Overload Identification:

CORRECTIVE ACTION:

FIGURE 1 - Solid State Overload Circuit Board

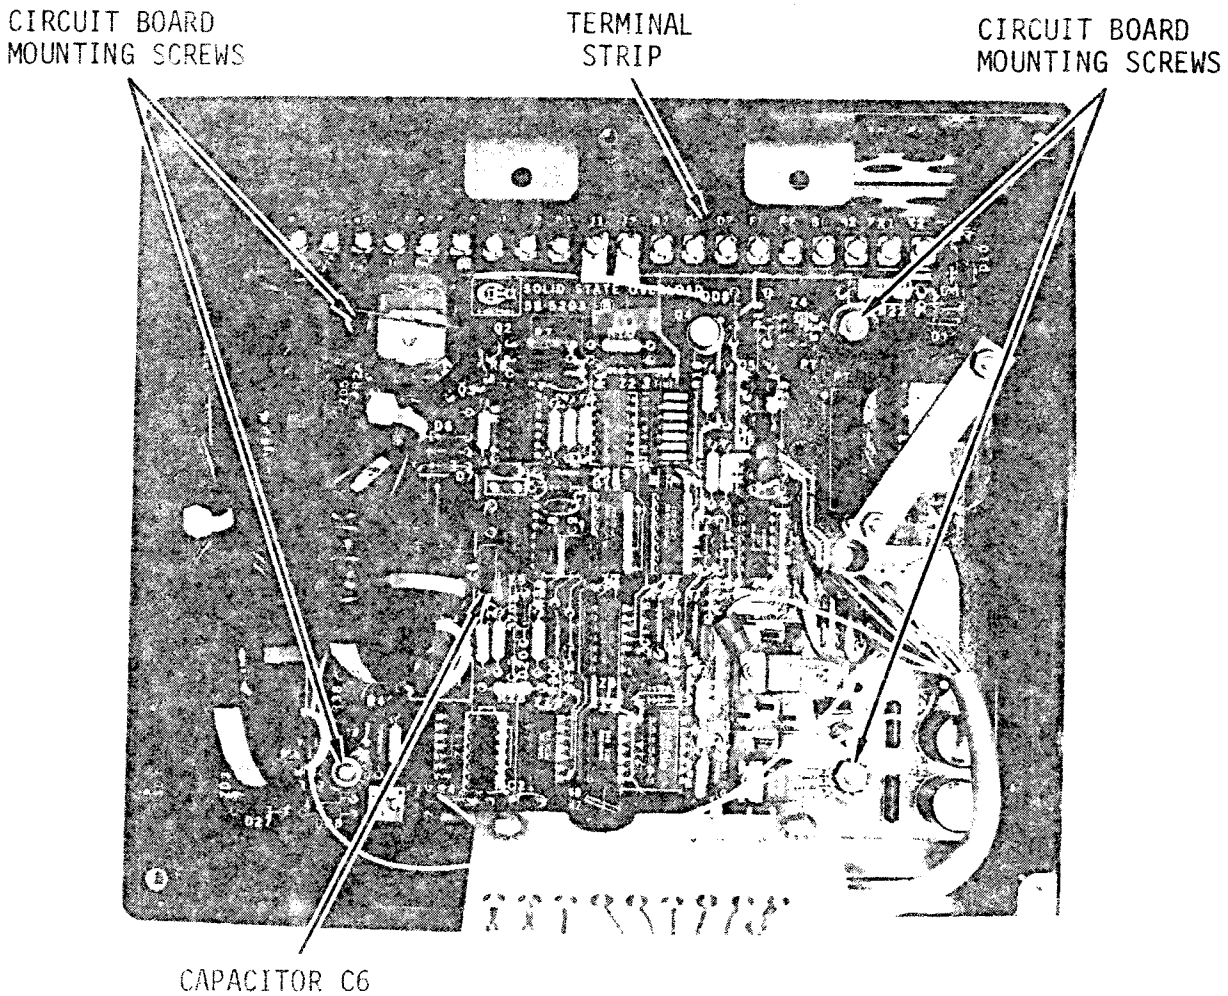
Before proceeding to the corrective action section of this bulletin, the overload module should be inspected to determine if it is the earlier version. Examine the terminal strip as shown in Figure 1. When looking into the SSOL with the terminal strip toward the top, as it is mounted in the starter, the fifth and sixth terminals from the right in an unmodified SSOL are labeled F1 and F2. Terminals 5 and 6 in a modified SSOL are labeled E1 and E2. The upper two screw terminals on the swing out of an unmodified SSOL circuit board are labeled F3 and F4. The modified SSOL terminals are labeled E3 and E4 (see Figure 2).

Corrective action involves replacement of the C6 capacitor on the main circuit board in the SSOL. The C6 capacitor originally supplied on all SSOL's provides approximately an 8 cycle delay after transition before the module begins to sense running current. The addition of a larger capacitor increases the delay time preventing nuisance tripouts. The C6 capacitor that needs to be replaced is shown in Figure 1. This designation is written on the circuit board next to the capacitor. The capacitor has a flat rectangular shape and is orange in color.

To remove the old capacitor, it will be necessary to remove the main circuit board. It is held in place by four screws located near the corners of the circuit board. See Figure 1. The board is held in place with electrical isolating washers and star lockwashers. Care must be taken to note the location of these parts while the board is being removed, so that they are replaced correctly.

For replacement, a 40 to 70 mf (micro farad) electrolytic capacitor rated between 35 and 50 volts should be used. Such capacitors are available at most electronic supply stores.

The correct polarization of the capacitor is with the positive (+) end toward the terminal strip.

Insert the new capacitor into the circuit board and solder in place. Be careful not to use too much solder. Excess solder can cause a short circuit on the circuit board. Clip the excess wire off the capacitor leads. Bolt the circuit board back into the black box. Be careful to reinstall all spacers and insulators in the correct position. Carefully reinstall the SSOL in the starter making sure it is wired correctly.

FIGURE 2 - Solid State Overload Swing Out Circuit Board

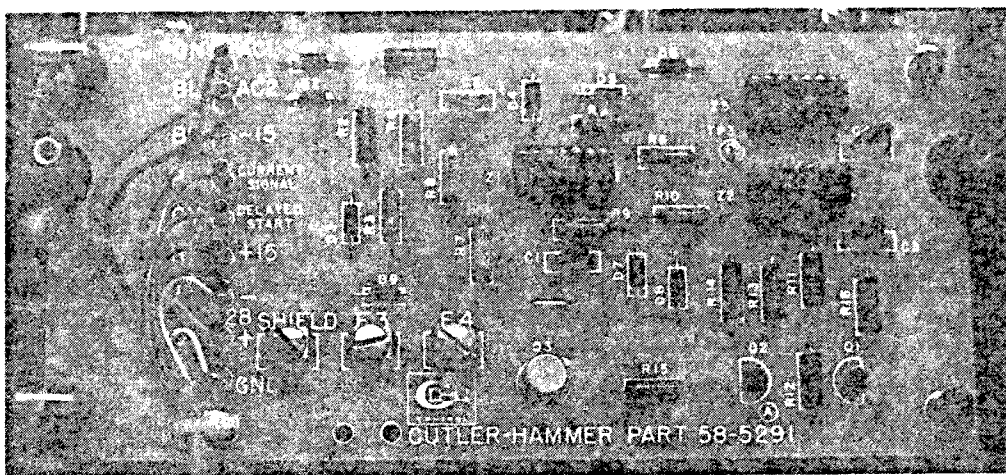
Any SSOL without the swing out circuit board is an unmodified model.

The modified SSOL has the changes described in this bulletin incorporated into its circuitry. Therefore, the modification described here is not applicable to a modified SSOL.
